TECHNICAL SERVICE BULLETIN

Bulletin Number: ATV-09-01

SUBJECT: 2009 Sportsman XP 850 Crankcase Breather Valve Replacement

Figure #3

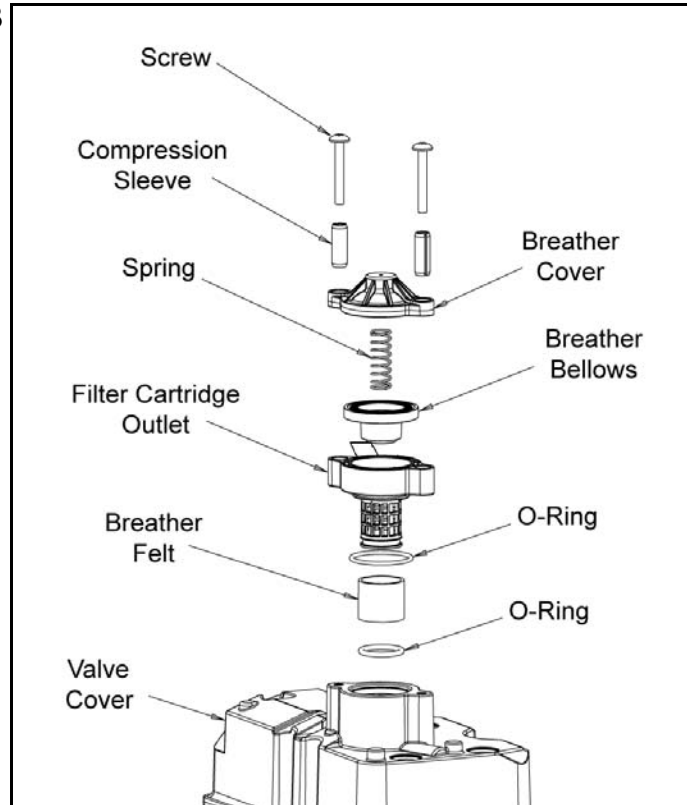
3. Install Crankcase Breather Valve Kit 2204191 according to the instructions provided with the kit (Figure #3). Duplicate copies of the kit instructions (PN 9922723) may be downloaded by accessing the 'Parts Detail Search' function on the Dealer Website..

4. Verify fasteners are torqued to **13 ft. lb. (18Nm)**.
5. Complete and place a Service Bulletin Decal in the specified location on the vehicle.
6. Reinstall the seat and verify it is secure.
